DELHI DEVELOPMENT AUTHORITY
(MASTER PLAN SECTION)

No. F.1(20)2001-MP/

**MINUTES OF THE MEETING OF TECHNICAL COMMITTEE HELD ON
04.07.2001 THE LIST OF THE PARTICIPANTS IS ENCLOSED**

Sub: Construction of Grade Separator at the intersection of Road No. 56, G.T. Road.
F.5(6)2001-MP

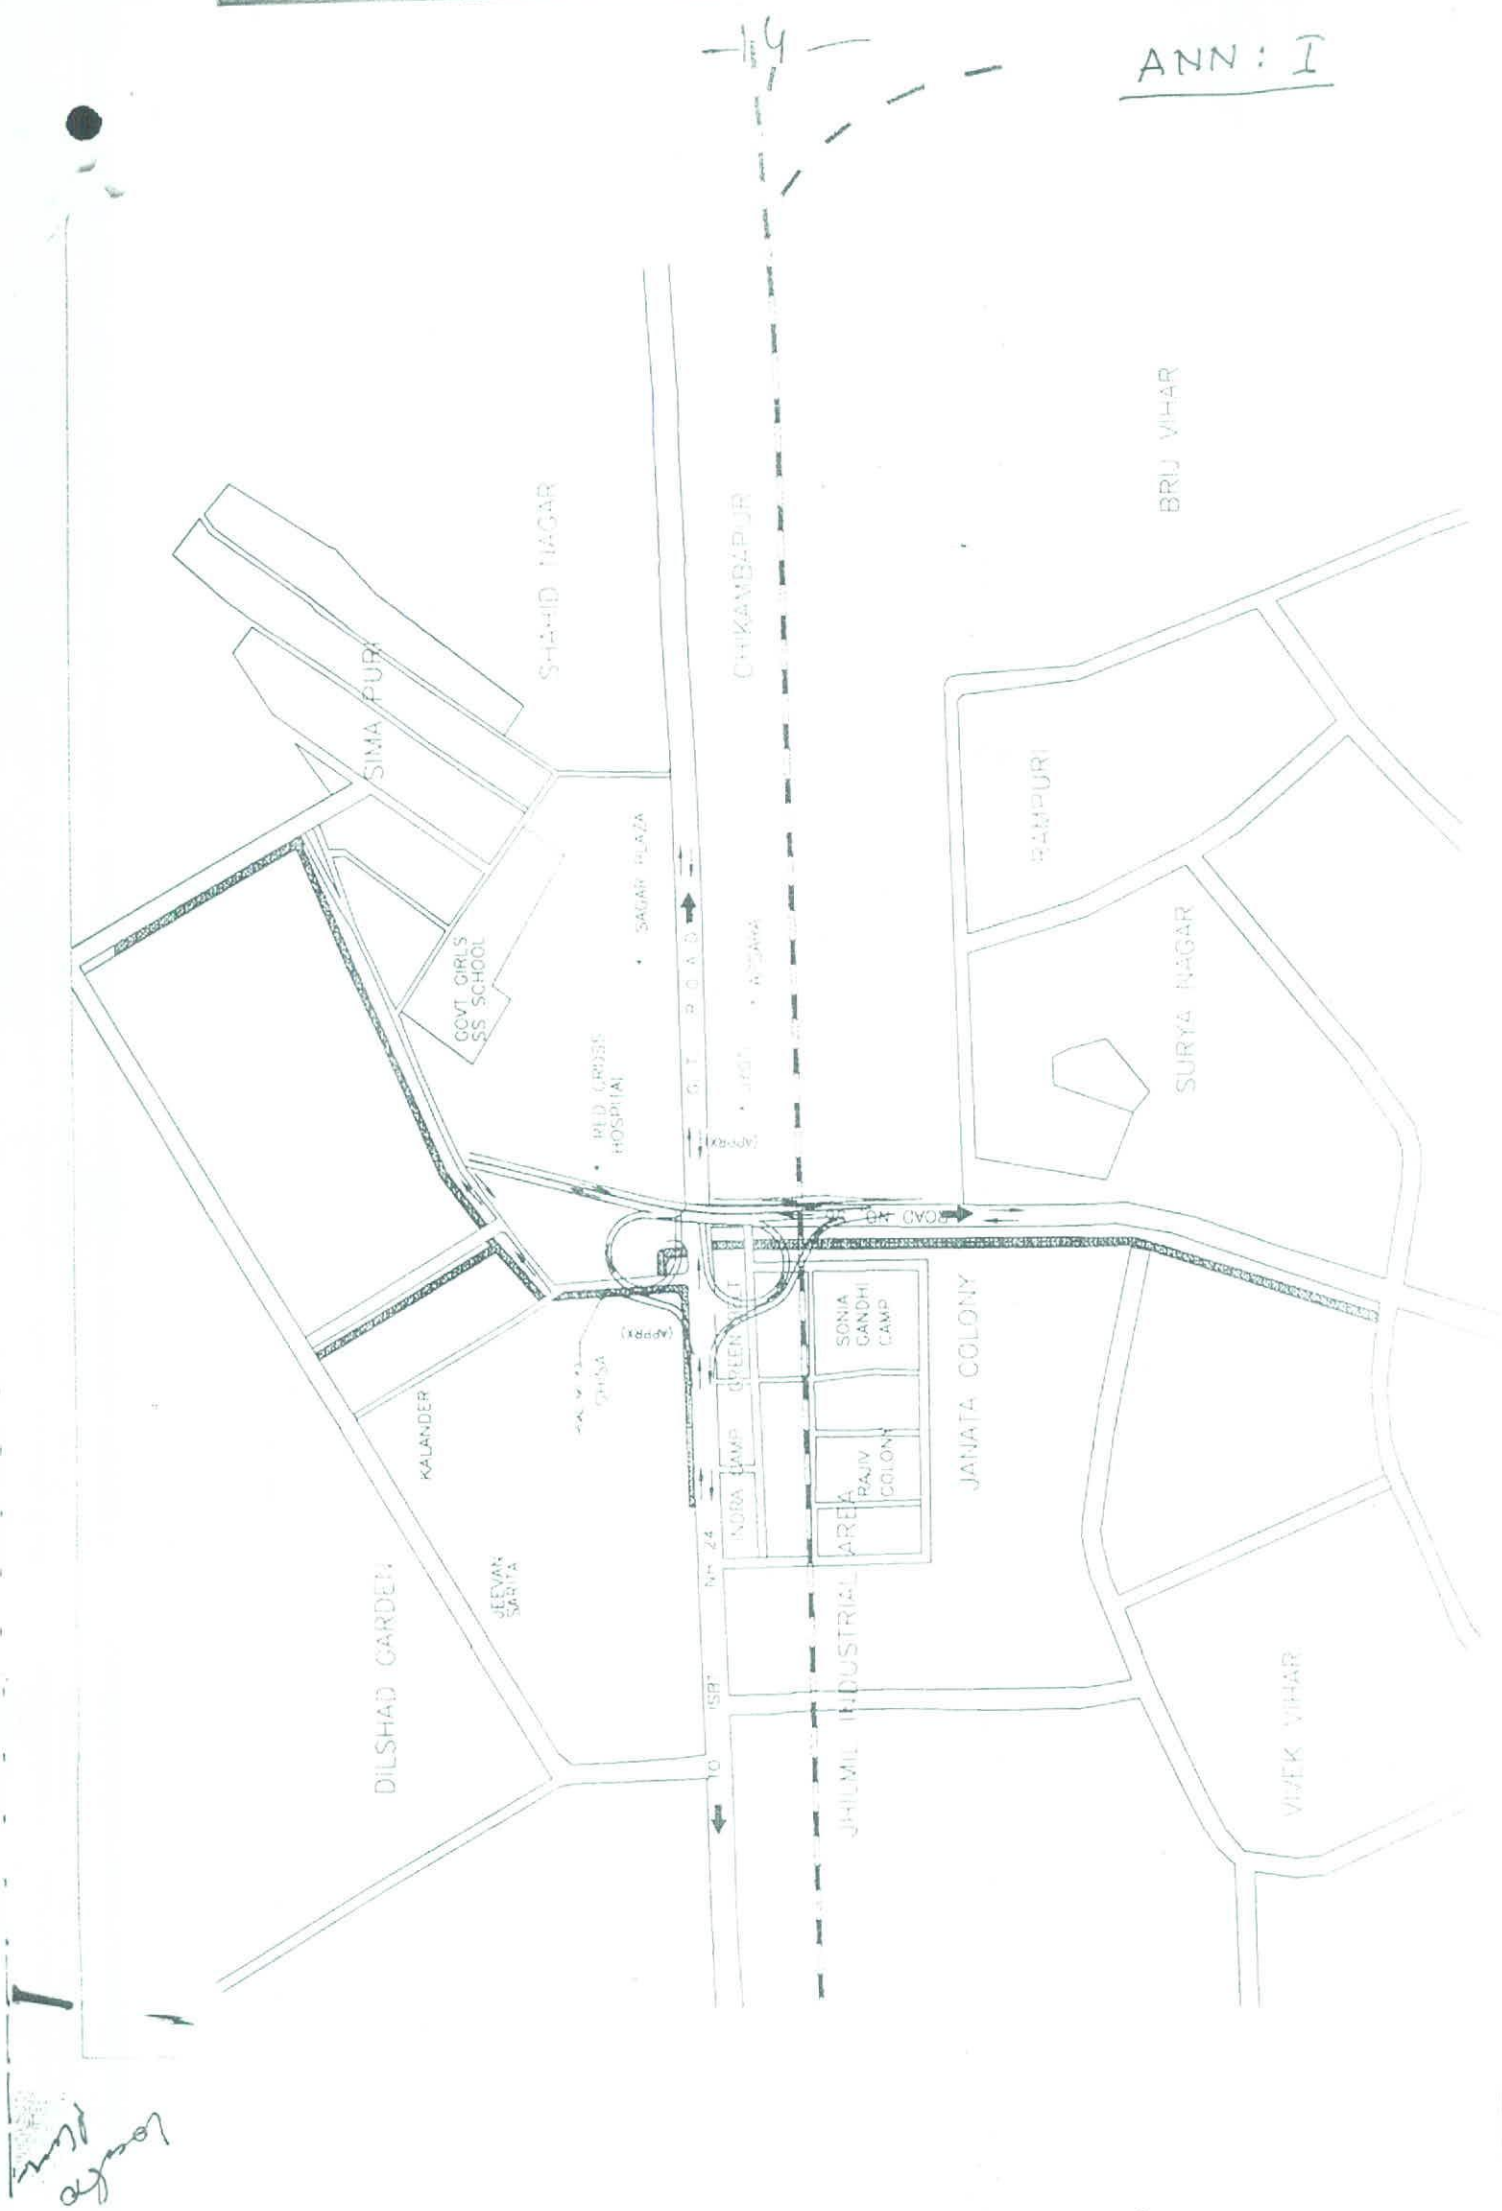
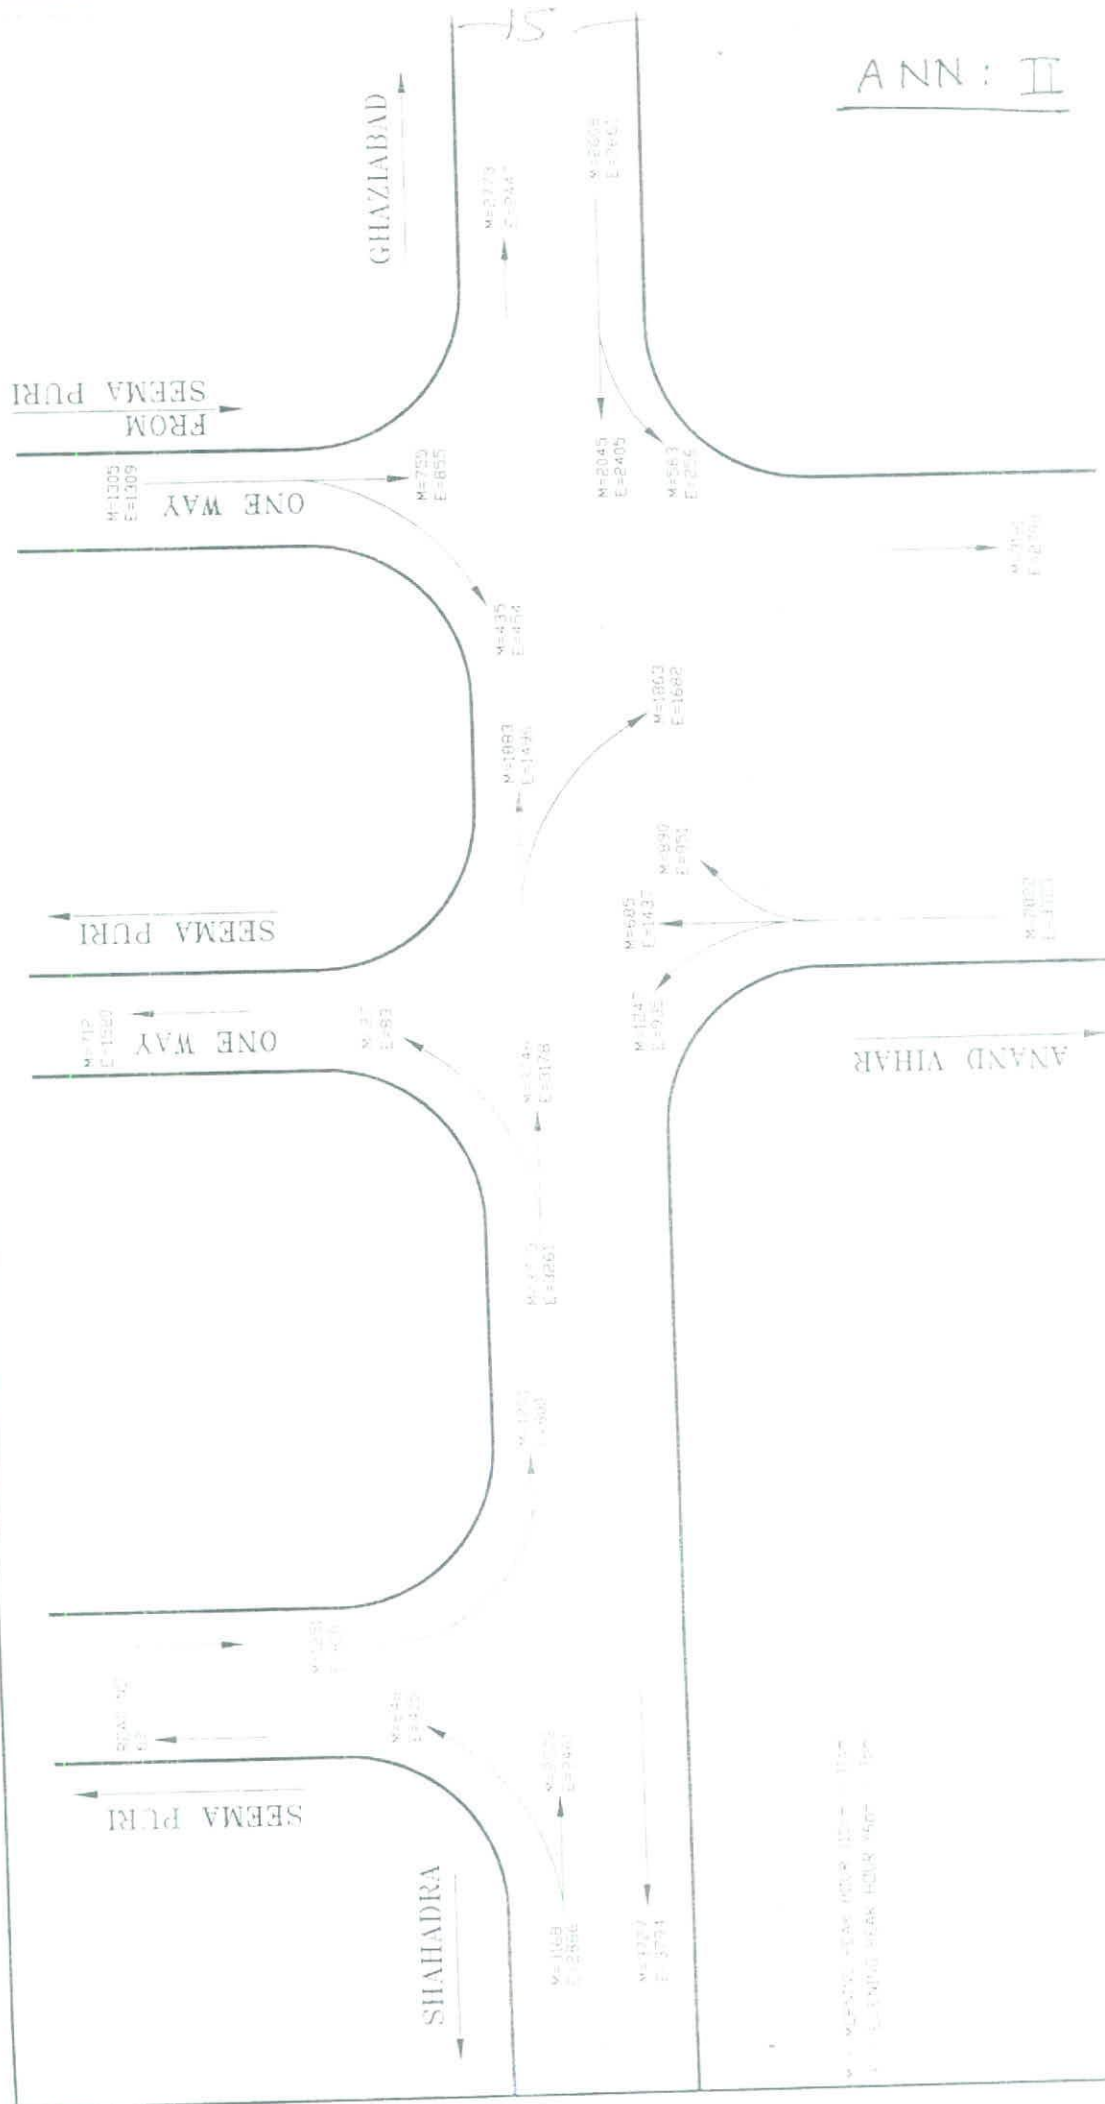
12. The land scape plan of surface level and above the fly over will be got prepared by the FWD. The necessary provisions in structure wherever requir-ed shall also be made. This shall be submitted to DUAC.

13. The traffic circulation plan during course of implementation of the project shall be prepared by implementing agency and got approved from the traffic police.

14. The consultant will submit two sets of complete drawings alongwith feasibility report/proforma duly signed by the Competent Authority for Office record after incorporating the T.C. decision and suggested modifications by the T.C. of the D.D.A.
